August 24, 2023

Re: Docket No. 508 - The United Illuminating Company Application for a Certificate of Environmental Compatibility and Public Need for the Milvon to West River Railroad Transmission Line 115-kV Rebuild Project - Request for Modification to Structure Locations Near West River Substation

CROSS SECTION 13 ELMWEST SUBSTATION TO WEST RIVER SUBSTATION (WEST HAVEN): STR P1034N AND STR P1038N

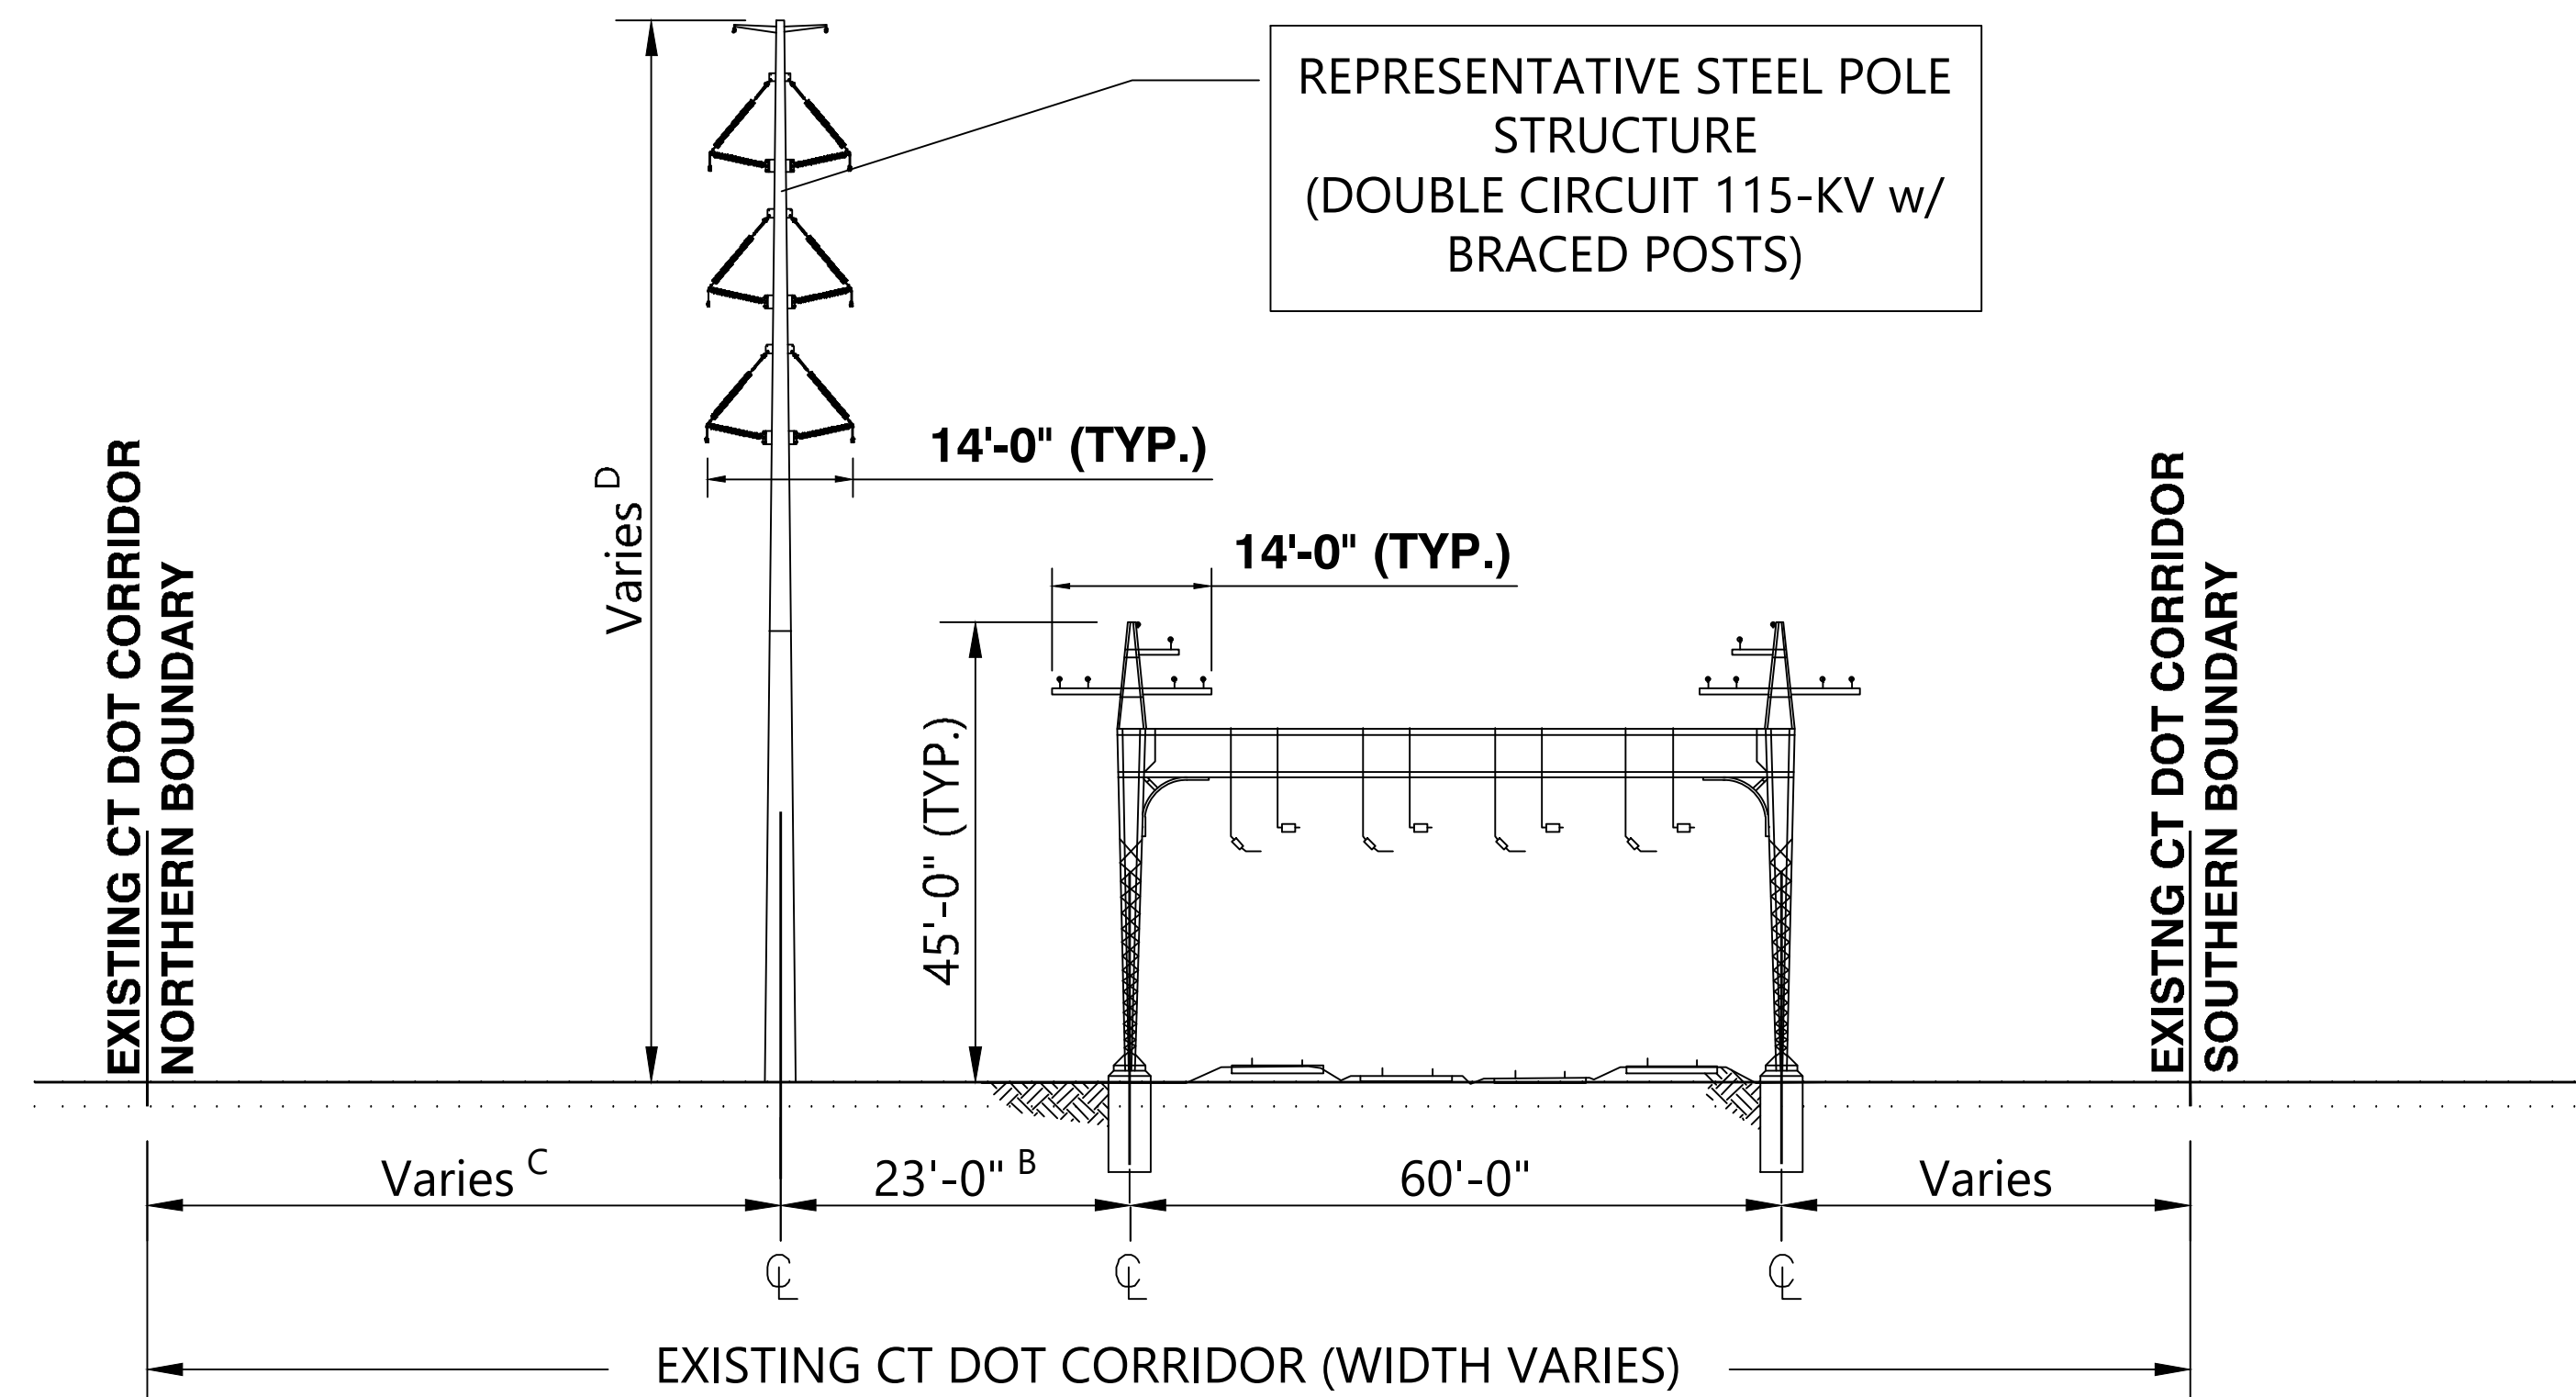
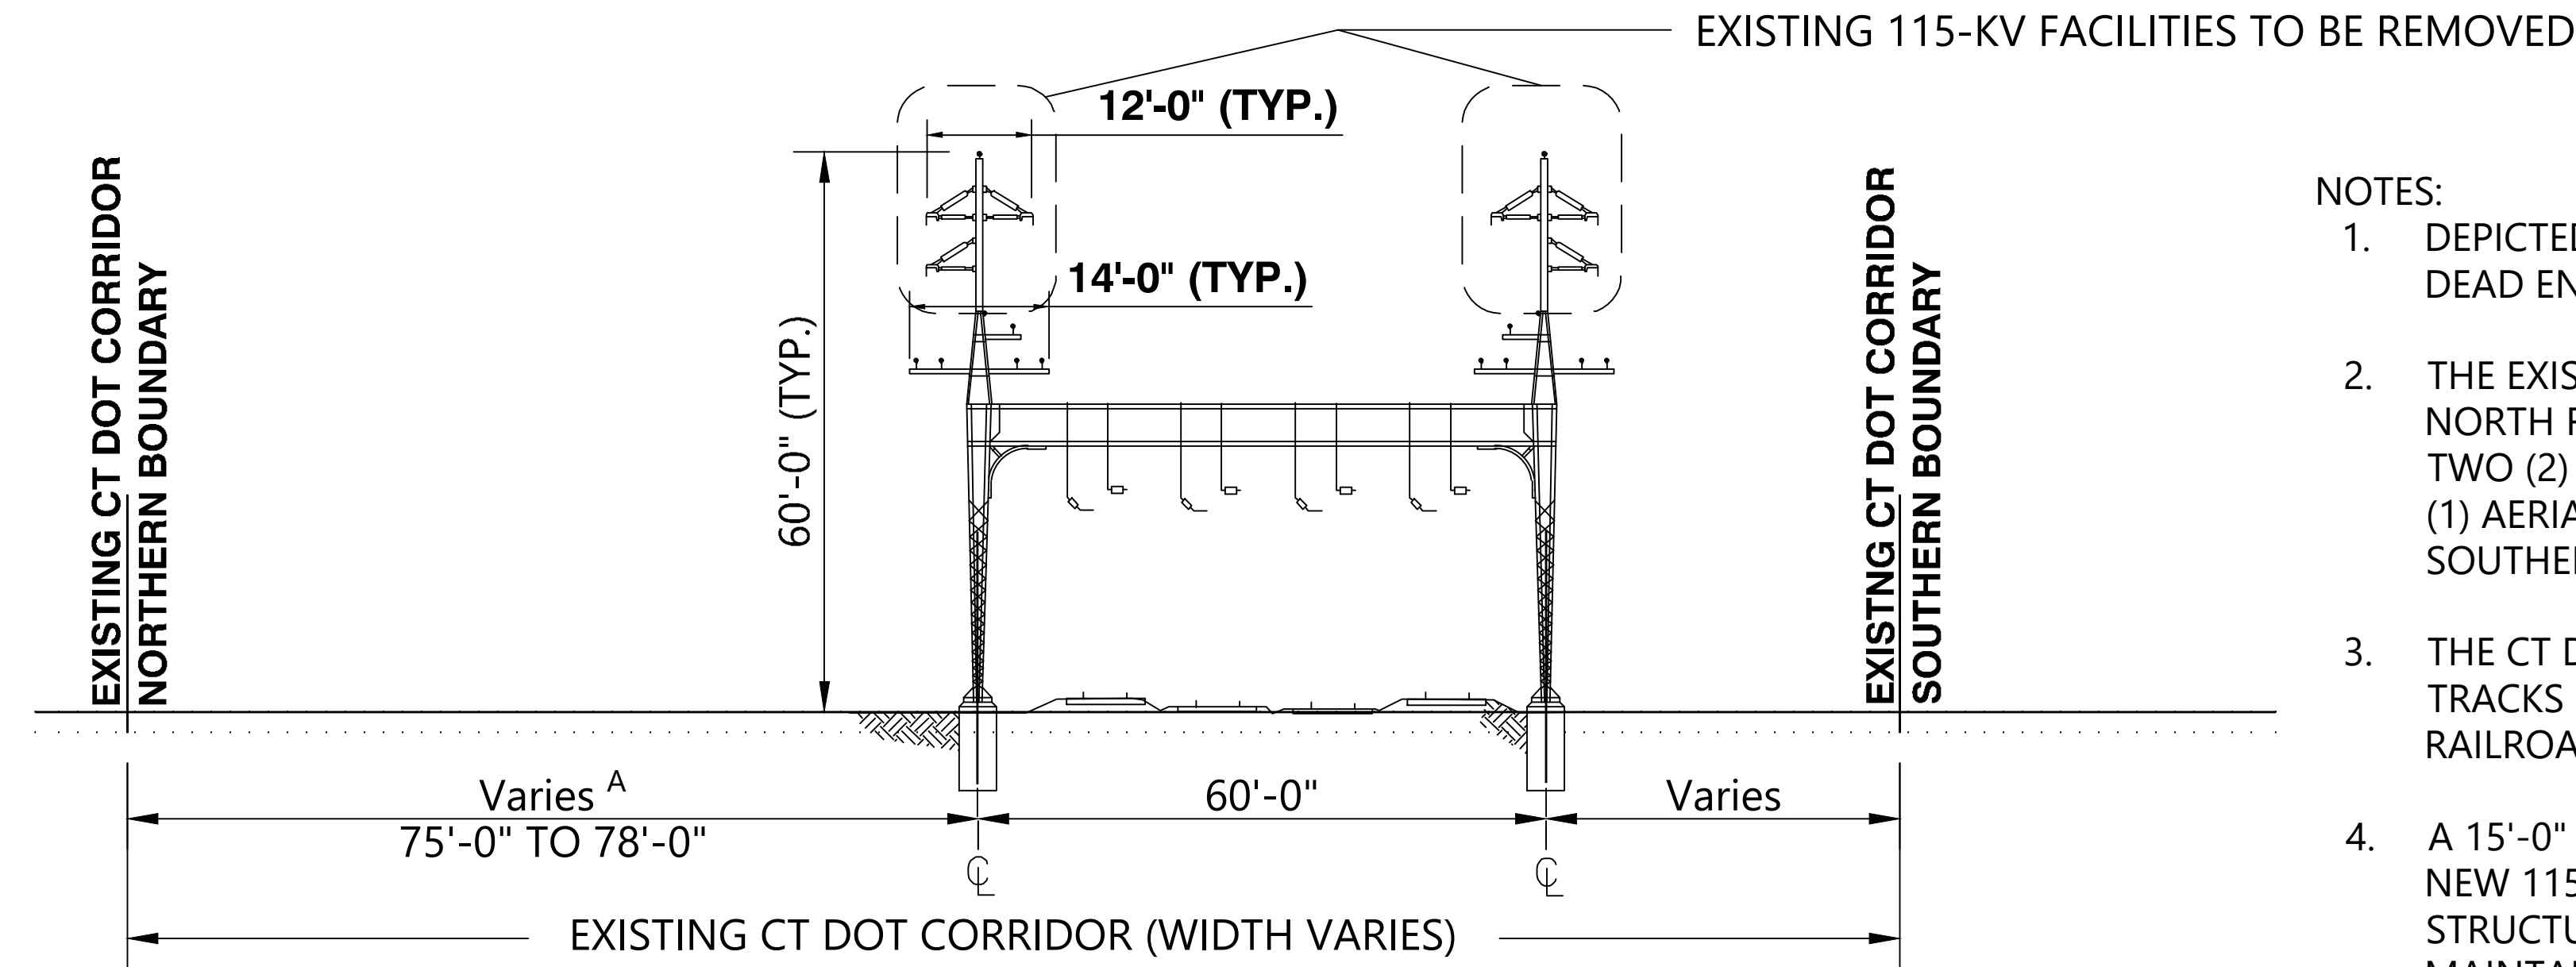
Structure No.	Pole Length (Original→Revised)	Structure Configuration (Original→Revised)	Transverse Offset* from Original Location (ft)***	Longitudinal Offset** from Original Location (ft)***
P1034N	100'→95'	Tangent w/ Braced Posts→ Deadend w/ Davit Arms	0	0
P1035N	95'→125'	Tangent w/ Braced Posts→ Tangent w/ Braced Posts	20	52
P1036N		Removed		
P1037N	95'→120'	Deadend w/ Davit Arms →Deadend w/ Davit Arms	47	33
P1038N	125'→125'	Tangent w/ Braced Posts→ Tangent w/ Braced Posts	0	35

- One of the double circuit steel monopoles originally planned for location along the north side of the MNR tracks in West Haven will be eliminated.
- Structures P1035N and P1037N will increase in height (to 120 and 125 feet, respectively) because of increased span length due to the elimination of P1036N and to maintain required vertical clearances for an adjacent building. These two structures were shifted farther north to accommodate the future planned spur tracks and work areas for MNR and CDOT.
- The realignment of P1035N and P1037N to the northern edge of the CDOT property will require easements on adjacent private properties, which will result in an additional 0.34 acre of permanent easements for the Project.

REV.	DATE	BY	DESCRIPTION	APP.	DATE:
0-0B	2023/07/31	WESTWOOD	SEGMENT 1 D&M PLAN UPDATED AT WEST HAVEN LUMBER YARD	DR: SFB	SCALE AS SHOWN FILE:
0-0A	2023/04/03	WESTWOOD	SEGMENT 1 D&M PLAN FOR CSC REVIEW	CK: JRD	NO.
				APP: MSP	XS 2 OF 3

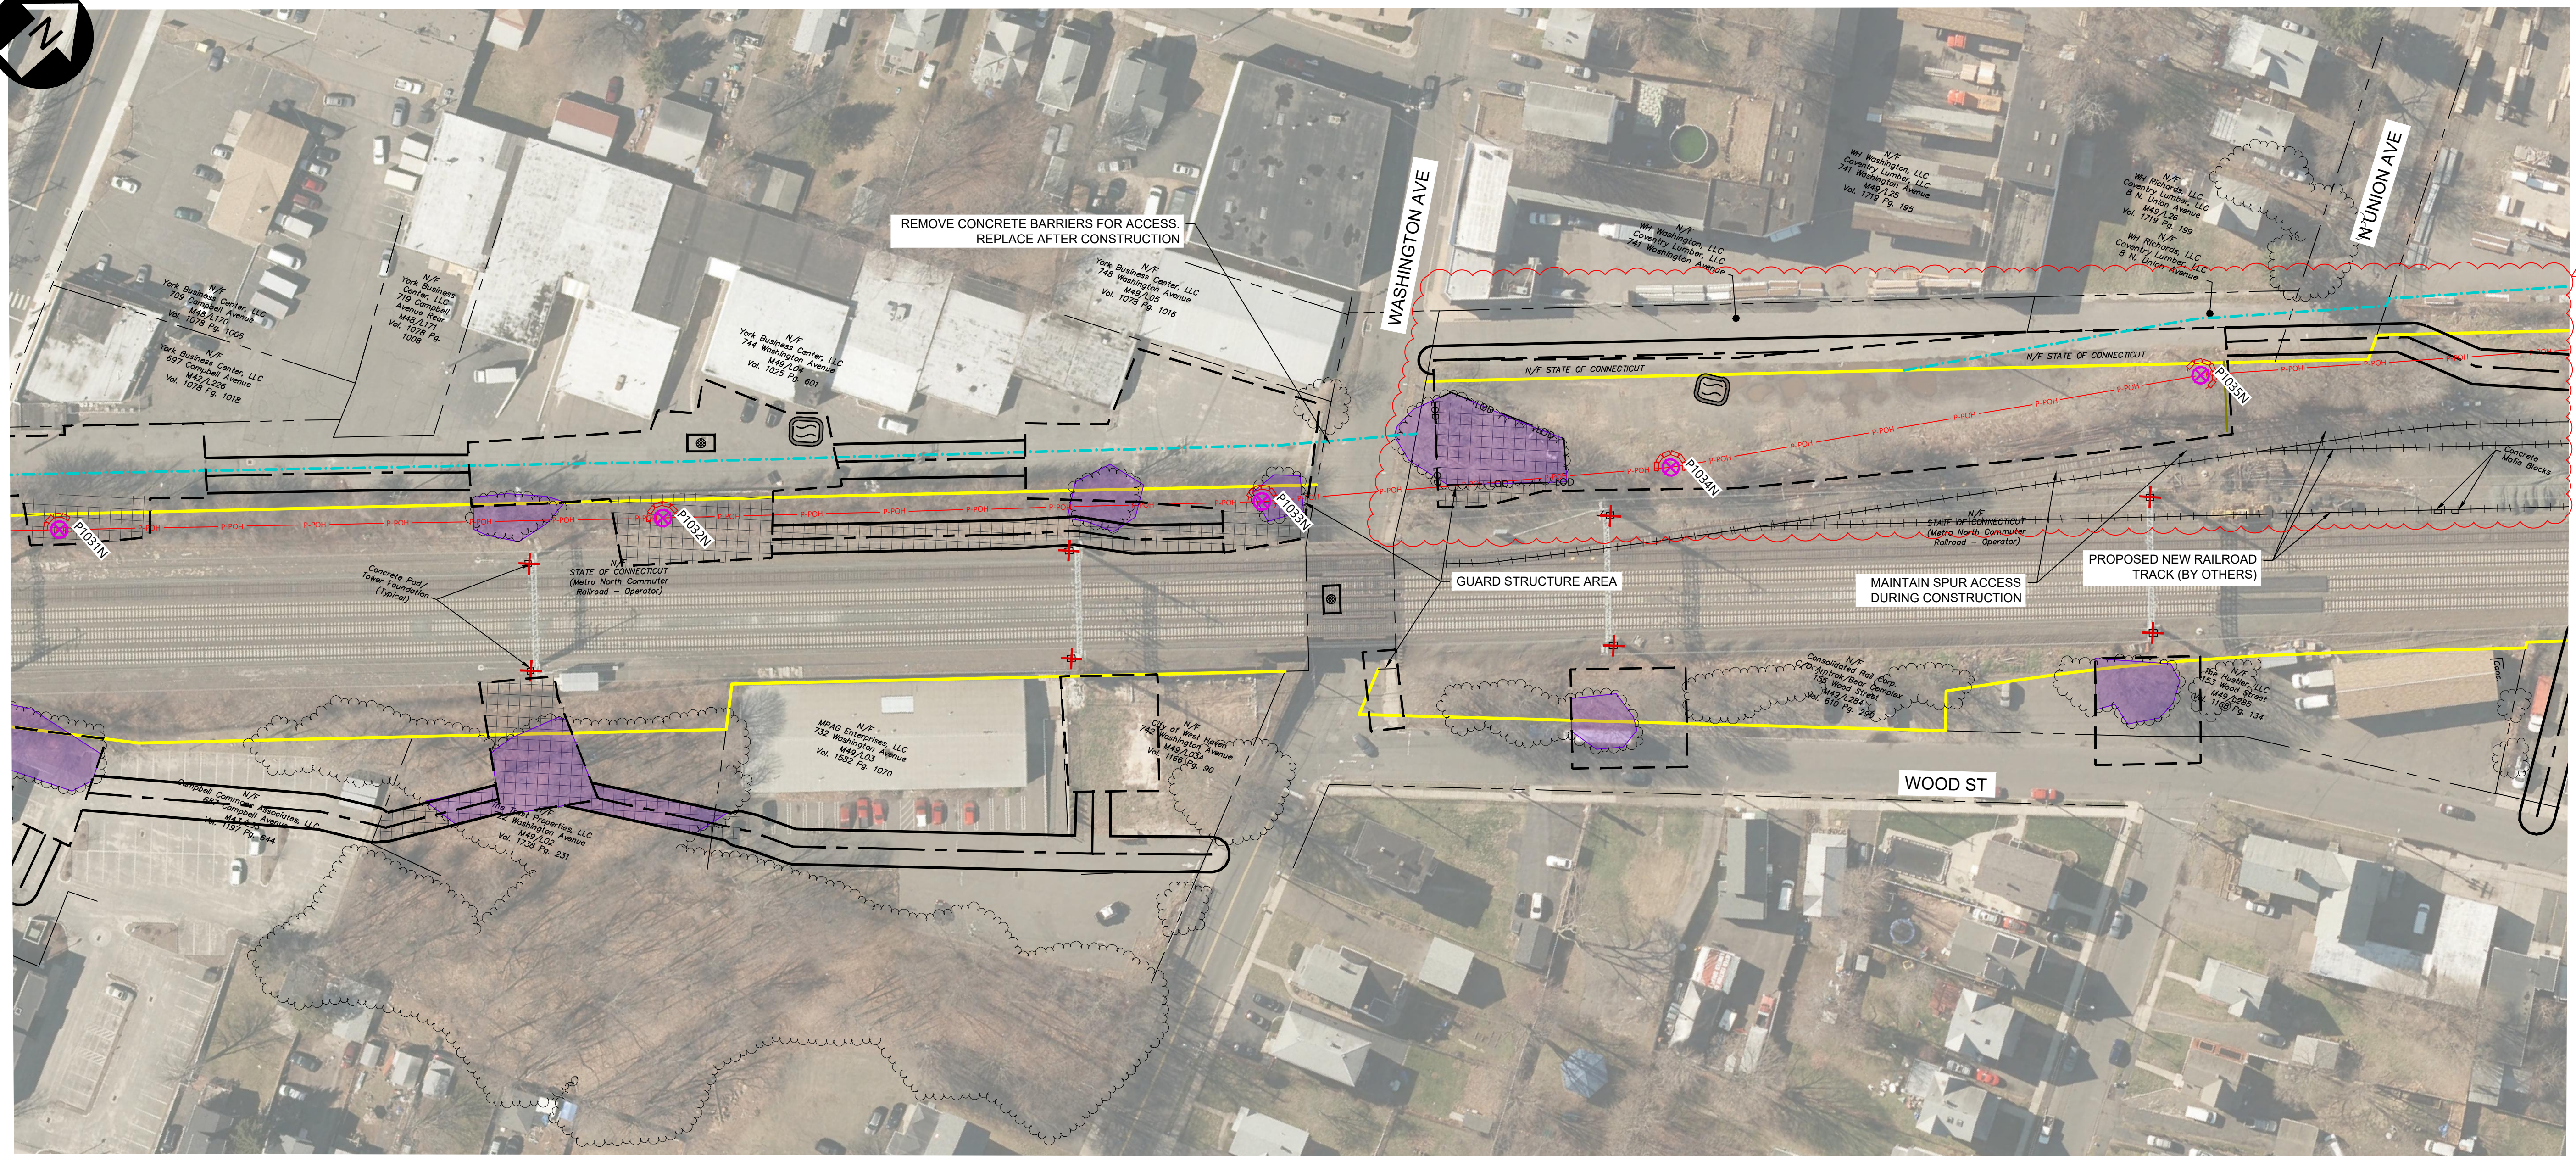
The Company received comments from the Connecticut Department of Transportation ("CDOT") on the positioning of transmission poles on CDOT property within CDOT's West Haven rail yard which is located north of the MetroNorth Railroad ("MNR") tracks (see Segment 1 D&M Plan, Volume 2, map sheets 2 and 3).¹ Based on those comments it was necessary for the Company to modify the location of the planned monopoles as follows:
